From: Monarque, Stephen
Sent: Monday, September 14, 2009 3:57 PM
To: ComanchePeakCOL Resource
Subject: FW: Responses to 41 Geotechnical Questions non public for now
Attachments: TXNB-09042 Geo RAI Pkg 3.pdf

CP-200901297
Log # TXNB-09042

**SUBJECT: COMANCHE PEAK NUCLEAR POWER PLANT, UNITS 3 AND 4
DOCKET NUMBERS 52-034 AND 52-035
PARTIAL RESPONSE TO REQUESTS FOR ADDITIONAL INFORMATION
NO. 1889, 2929, 2930, 3015, 3016, AND 3080**

Figure 1: Logic tree of return period and characteristic magnitude for the Meers fault.

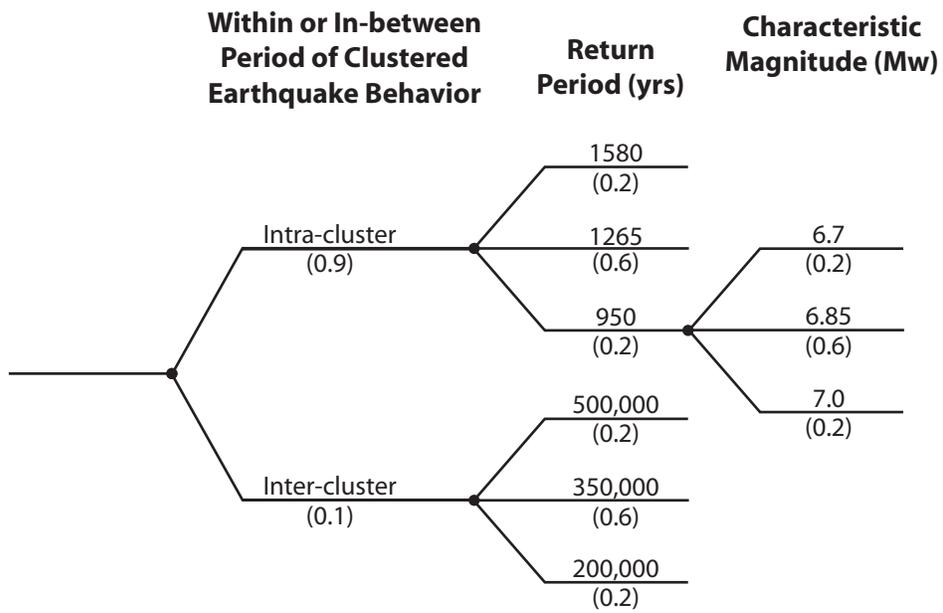
In Subsection 2.5.2.4.2.3.2.3 you stated that “Epistemic uncertainty in return periods for characteristic earthquakes on the Meers fault is implemented through return period branches on a logic tree.” The FSAR does not include this logic tree. Please provide a copy of this logic tree.

The logic tree (Figure 1 attached) used to represent epistemic uncertainty in the return period and magnitude for characteristic earthquakes on the Meers fault is attached. The details of this logic tree are described in FSAR Subsection 2.5.2.4.2.3.2.3.

FIGURE 1

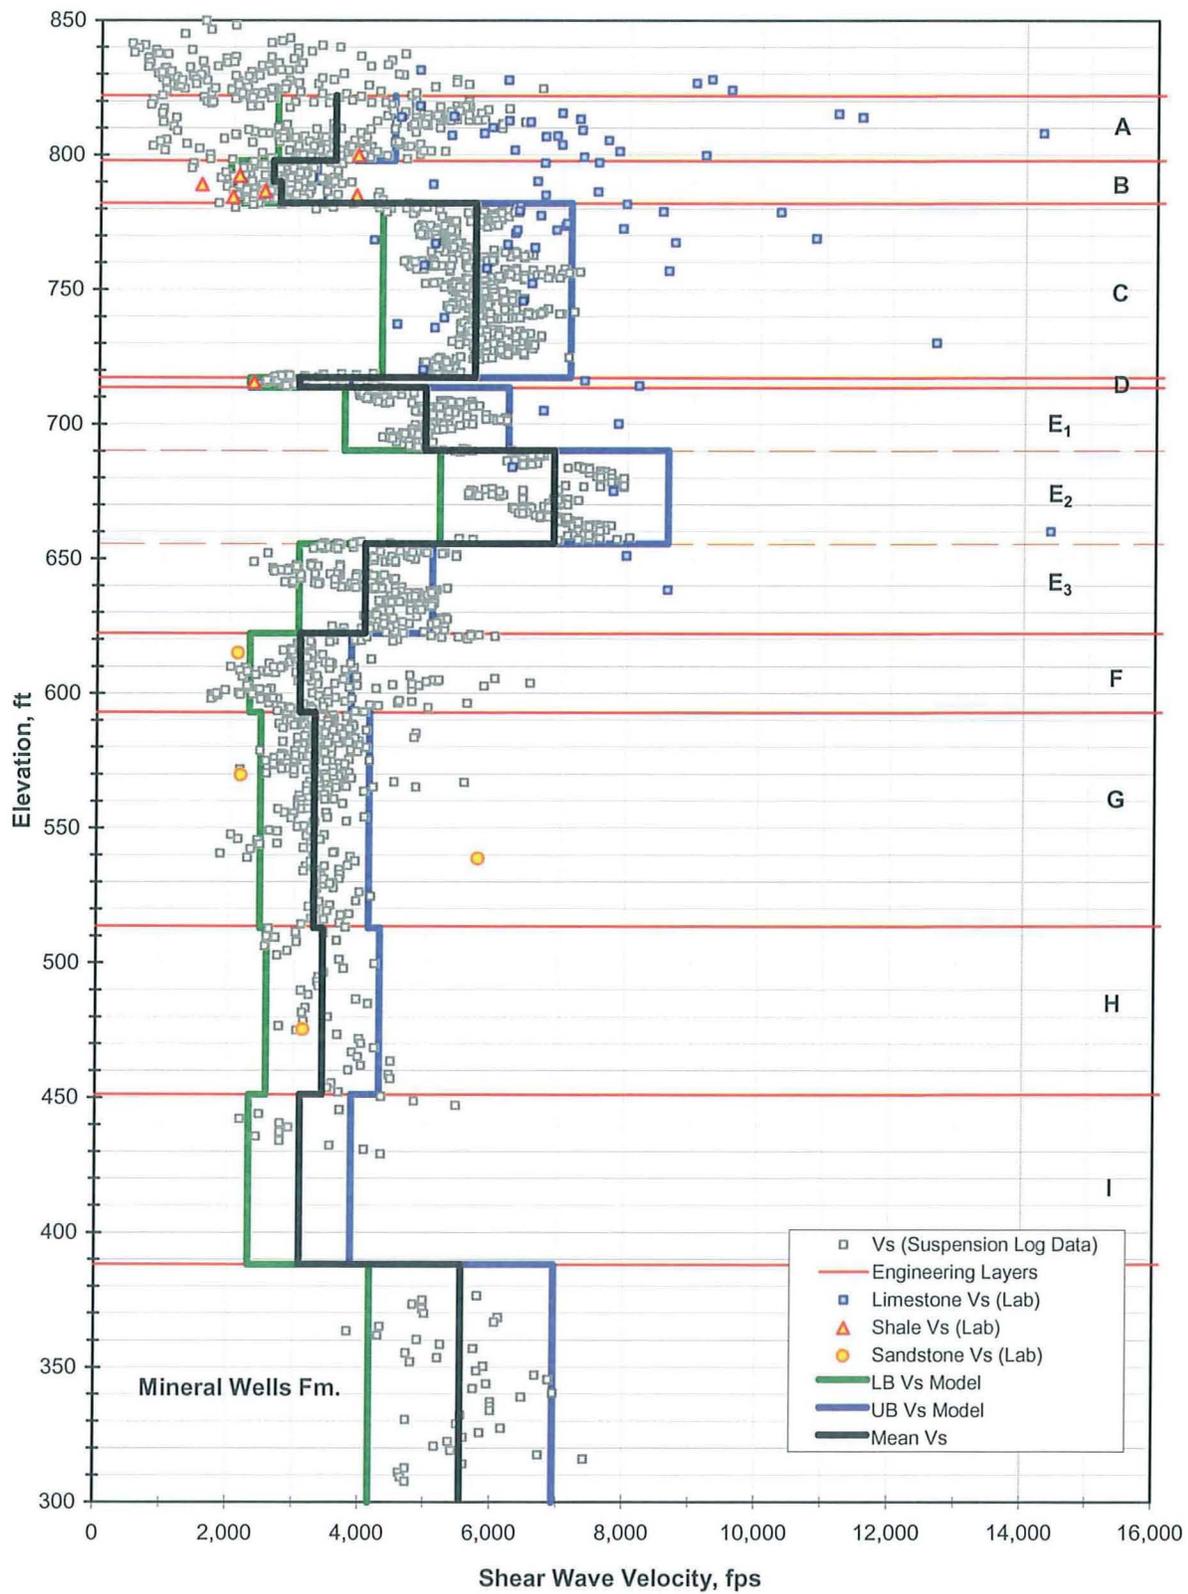
FSAR Section 2.5.4.2.2.16 "Laboratory-Based Shear Wave Velocity" mentions that laboratory measurements of shear wave velocity on relatively undisturbed samples of shale, limestone and sandstone were performed. This section indicates that this testing was performed to determine the rock's degree of disturbance. FSAR Figure 2.5.4-238 provides Laboratory Shear Wave Velocity measurements vs. elevation. Given the large degree of variability in shear wave velocities encountered in the limestone layer, please discuss how this meets the uniformity criteria mentioned in FSAR Section 2.5.4.2.

Shear wave velocity was measured for a number of rock core samples (FSAR Figure 2.5.4-238) as part of the laboratory testing program. Because laboratory tests are performed on relatively small (2.5-inch diameter), intact specimens, the effects of weathering, fissures, and discontinuities of the larger rock mass typically are not reflected in the results. Figure 1 shows results of the laboratory shear wave velocity measurements (FSAR Figure 2.5.4-238) combined with the in situ shear wave velocity data

obtained by the downhole suspension P-S logging method (FSAR Figure 2.5.4-239). The mean shear wave velocity based on the suspension P-S logging data and the selected ranges for the lower- and upper-bound suspension-log models are also shown on Figure 1. Generally, laboratory-measured shear wave velocities are higher than those measured in the field because the small lab samples lack the rock-mass discontinuities present in the field, as reflected by the data obtained for this site (Figure 1). For these reasons, it was judged that the results of the laboratory shear wave velocity measurements did not provide a good overall representation of the subsurface mass properties. Consequently they were only used as an indicator of the degree of weathering and soundness of the rock specimens and not used for formulating the site shear wave velocity model.
